Re: Aurora One – Master Plan Amendment with Adjustment
Application Number: DA-2241-08
Case Number: 2020-7004-01

Initial Submission Review

AURORA ONE PUBLIC IMPROVEMENT PLAN (PIP)

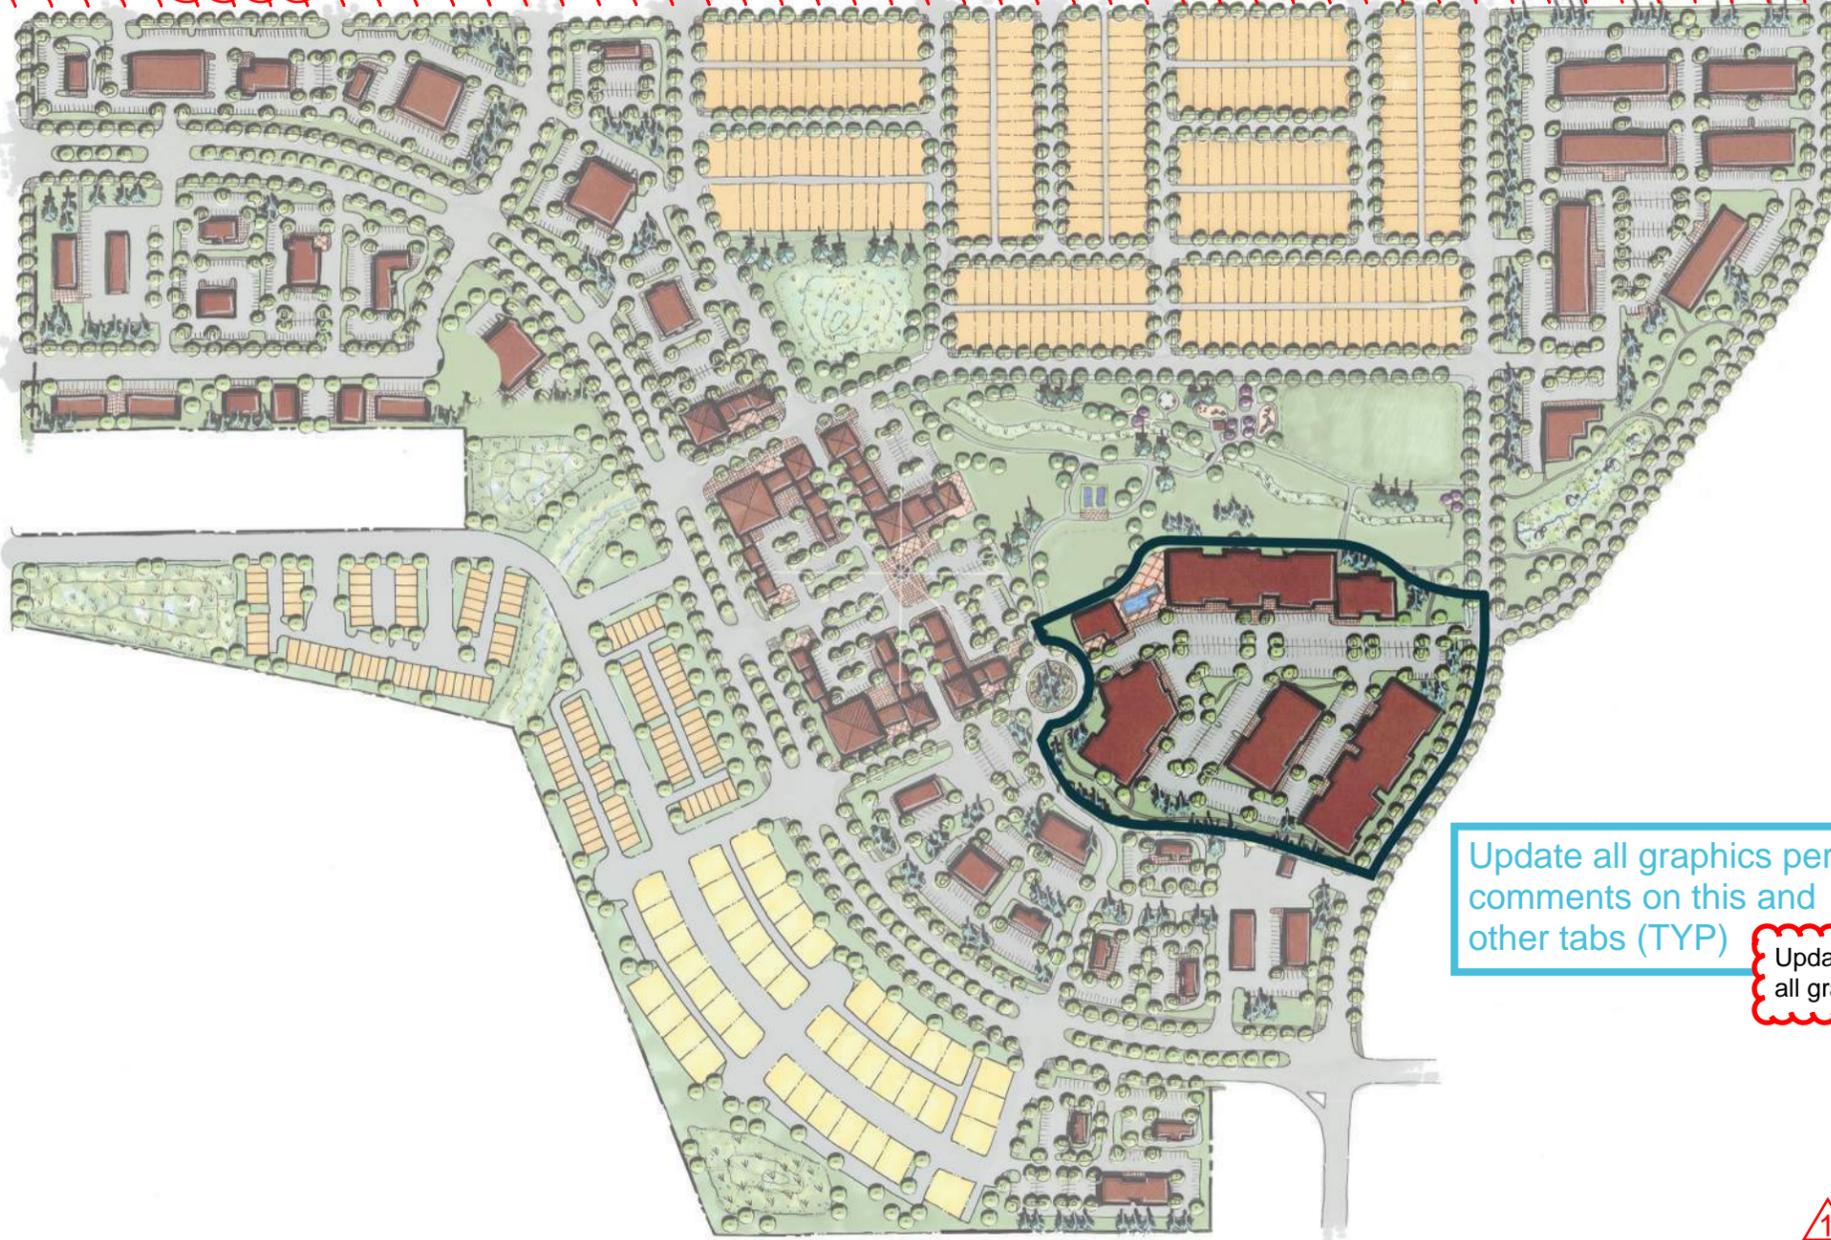
Remove this note

Removed

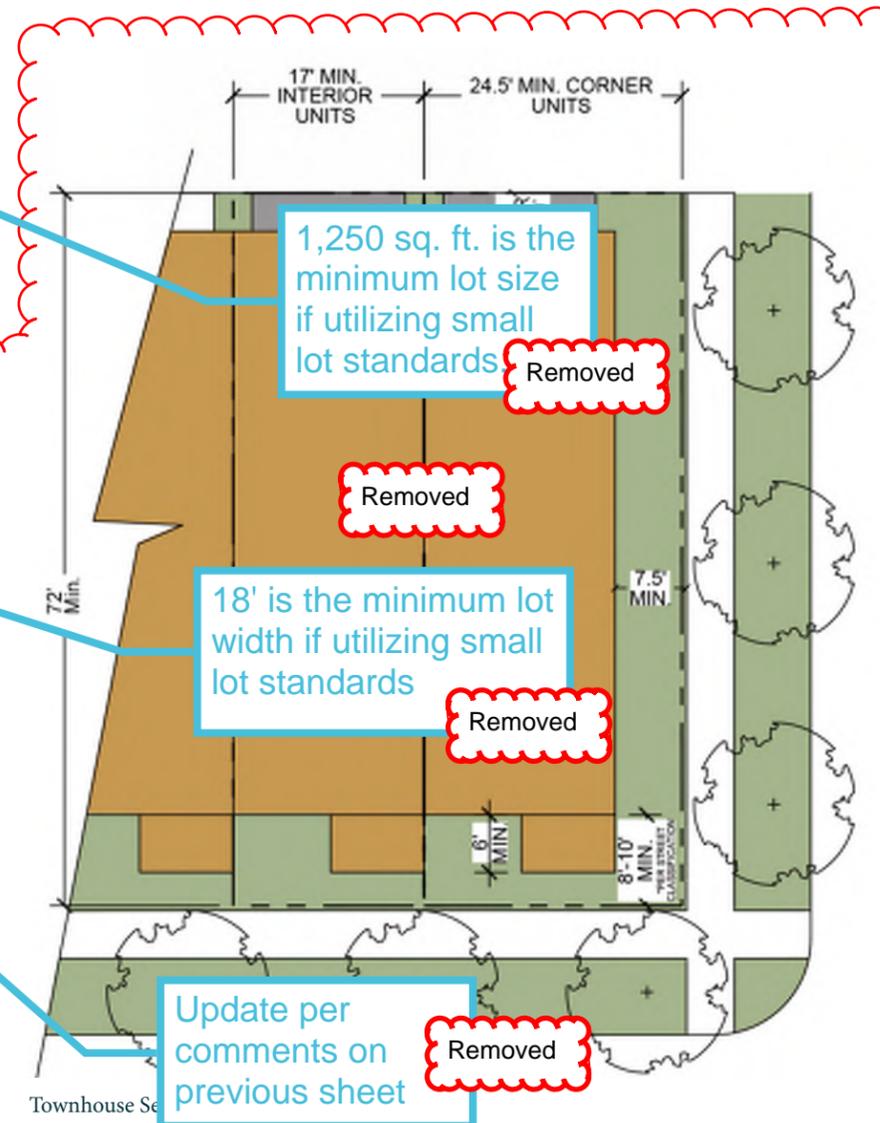
Depending upon the open space, a 25' special landscape buffer would be required in this scenario for townhomes, not 5'

Removed

AURORA ONE PUBLIC IMPROVEMENT PLAN (PIP) PLANNING AREAS PA-1 EXHIBIT

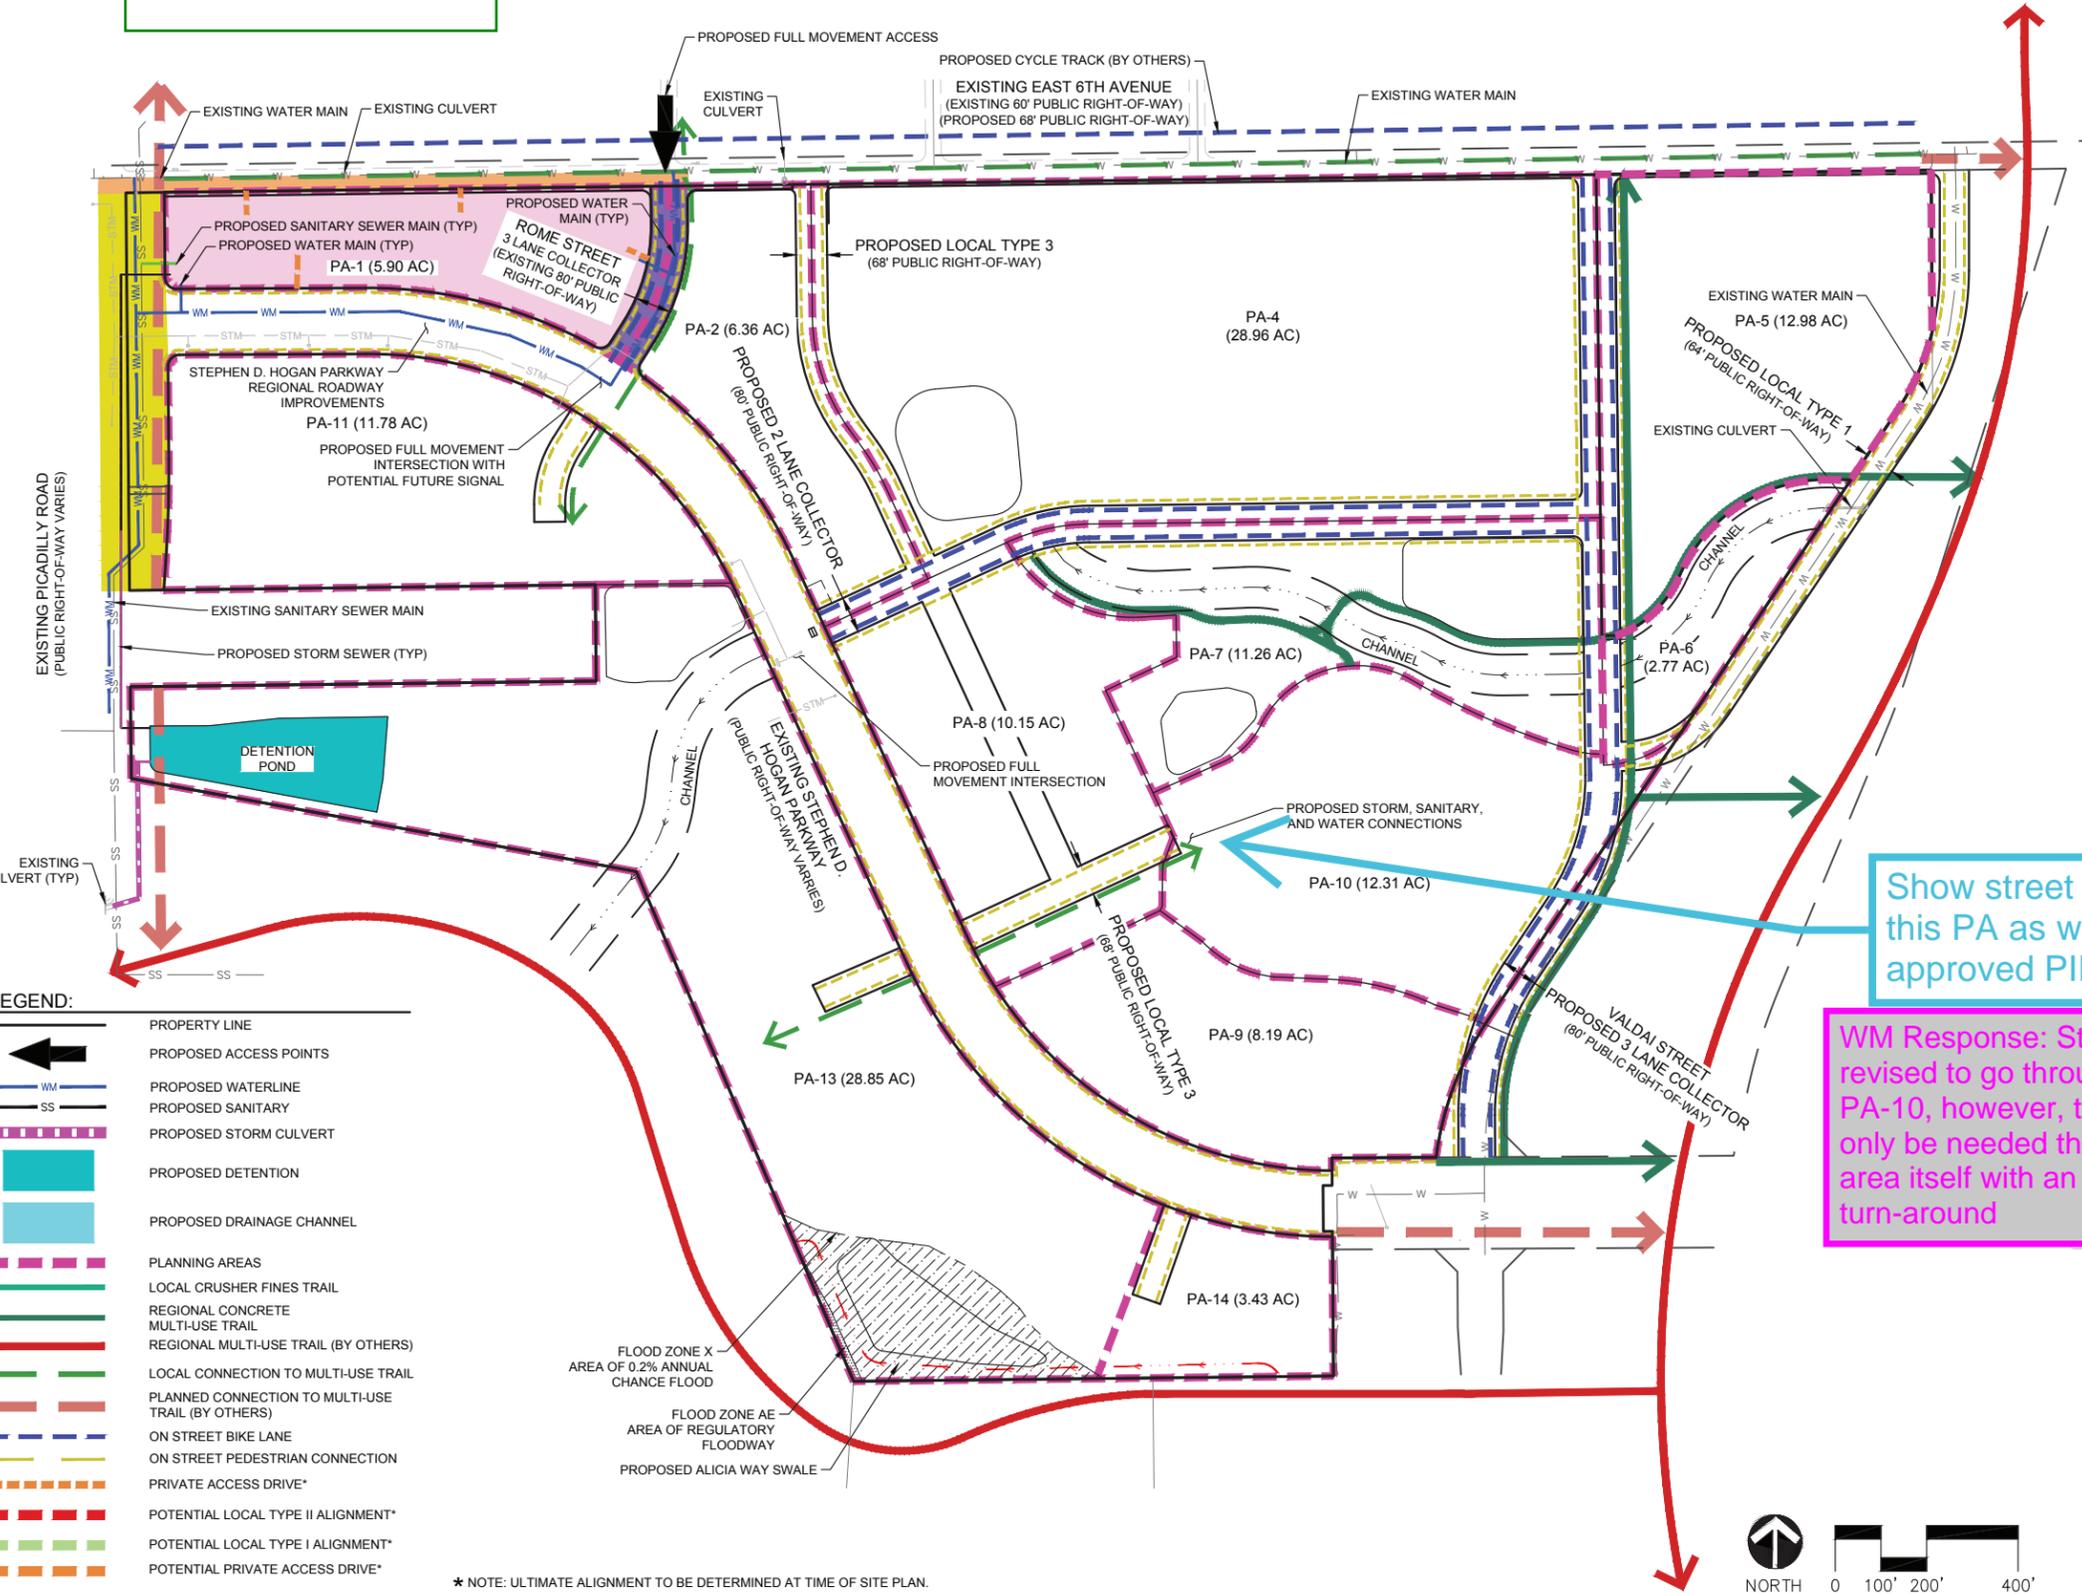
Show street continuing through this PA as was shown in the approved PIP (TYP)

WM Response: Street has been revised to go through PA-8 and PA-10, however, the section will only be needed through the planning area itself with an appropriate turn-around

AURORA ONE PUBLIC IMPROVEMENT PLAN (PIP) PLANNING AREAS PA-8 EXHIBIT

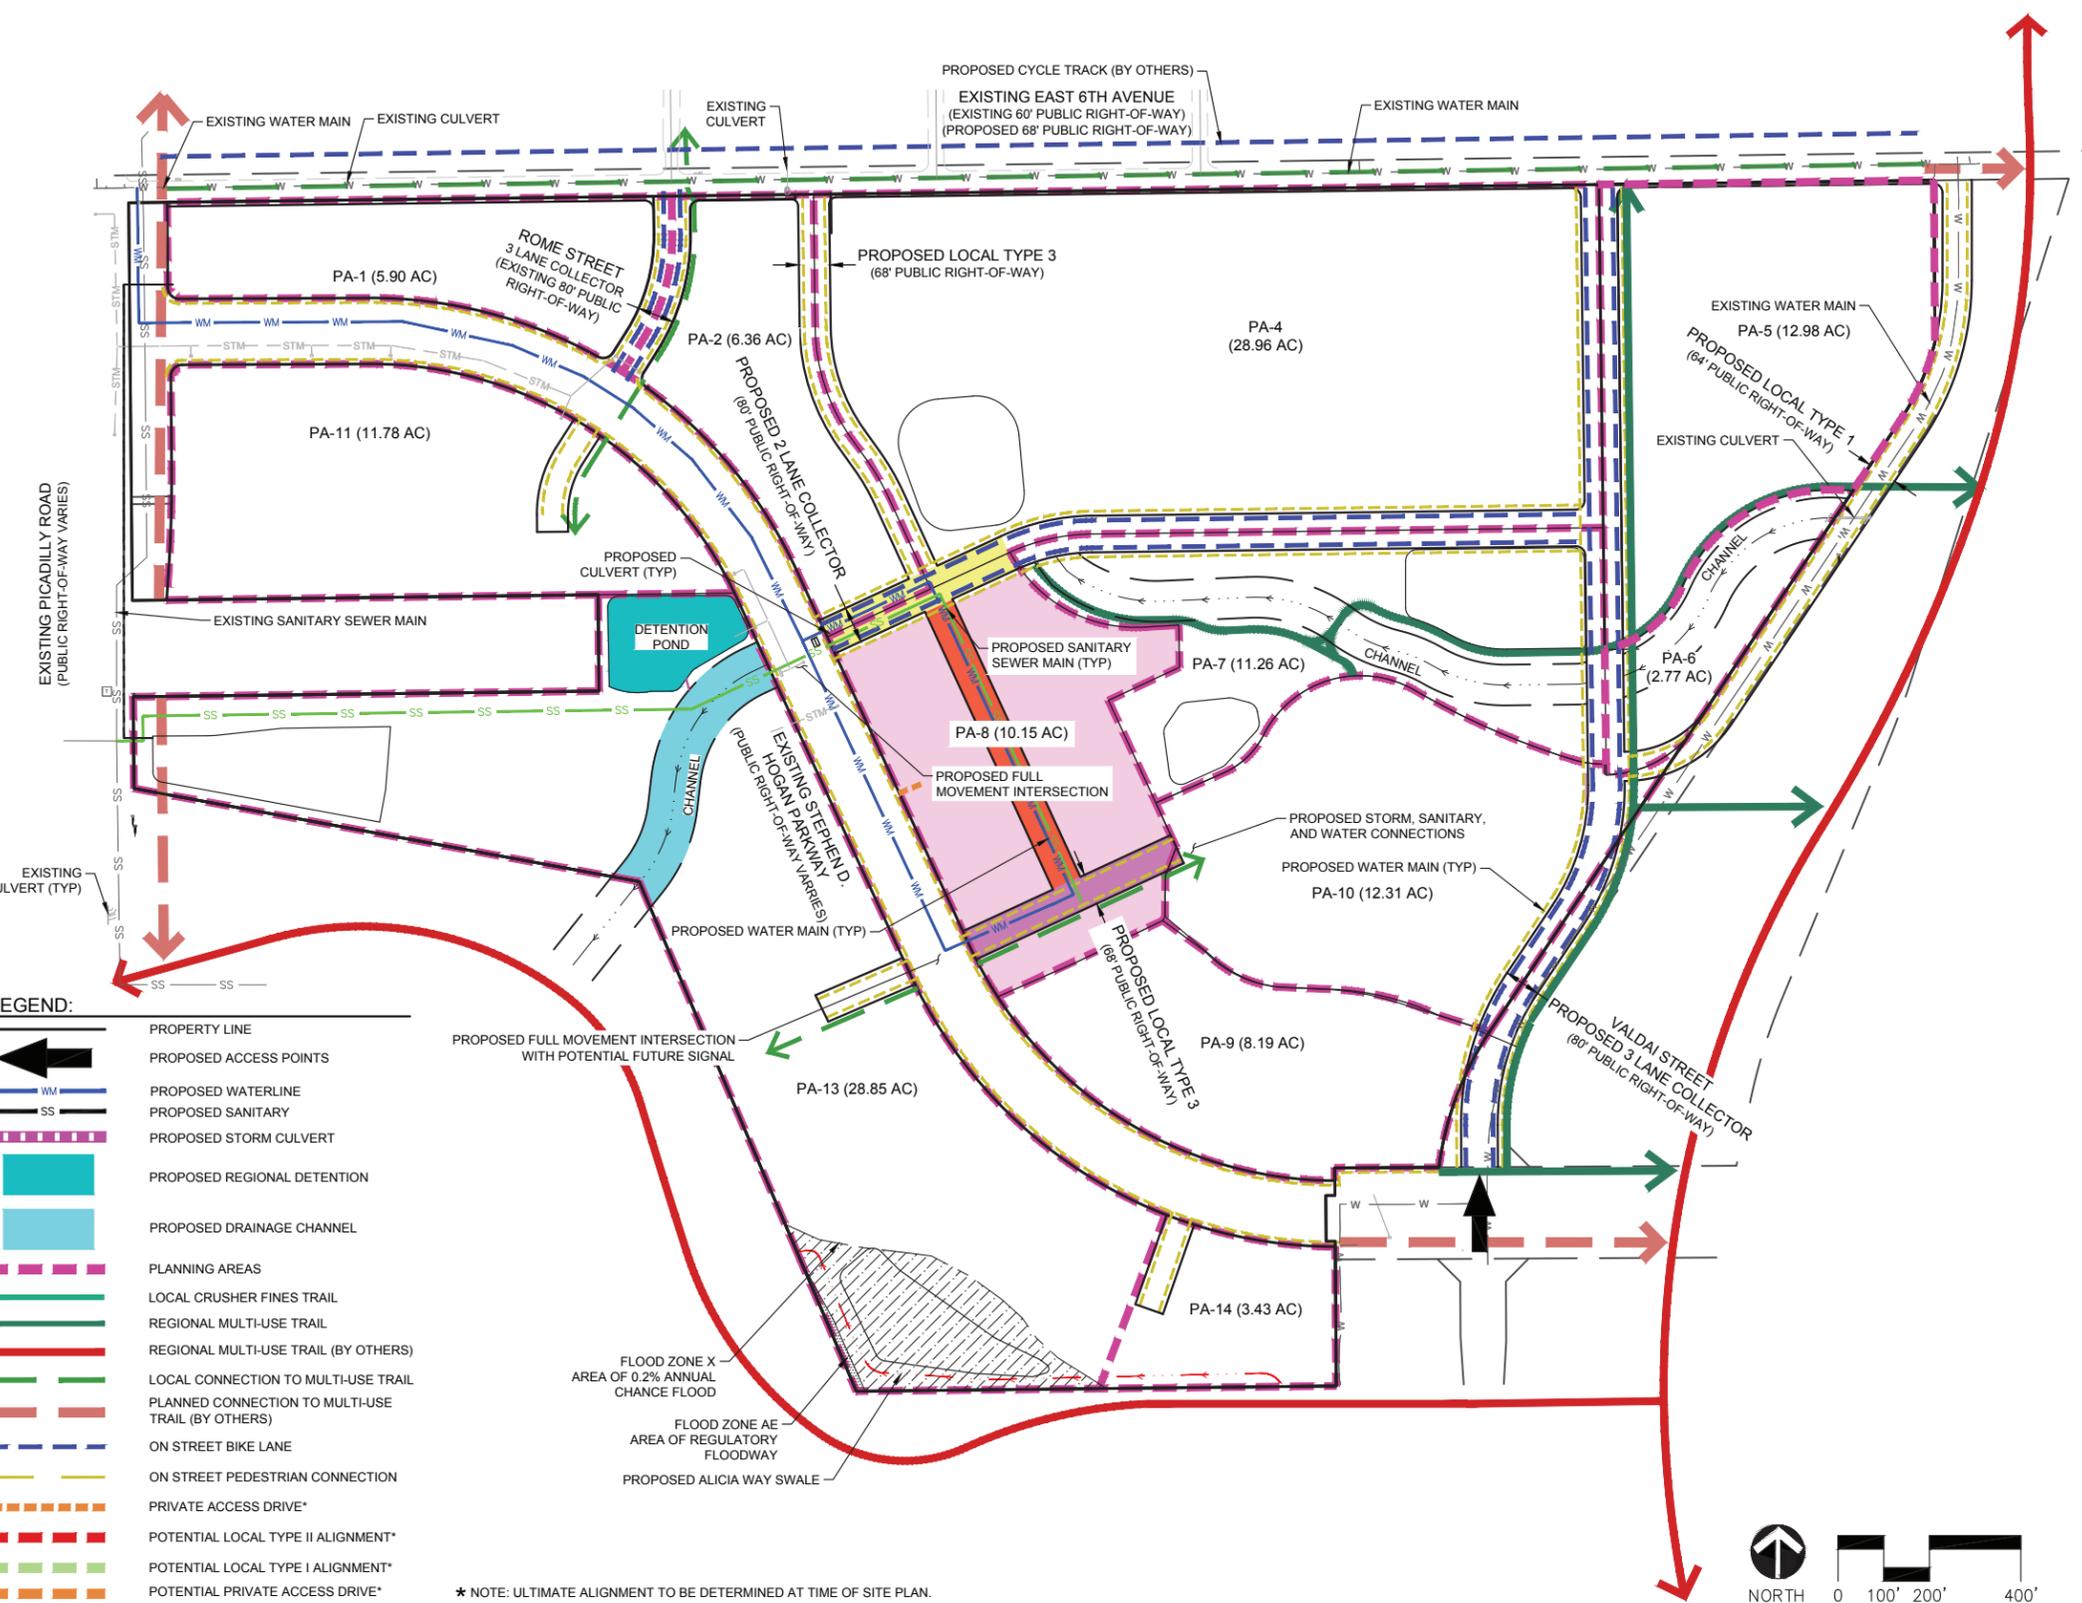
3J. The Valdai Street improvements do not match the exhibit for PA-8. *The report and text have been revised for consistency.*
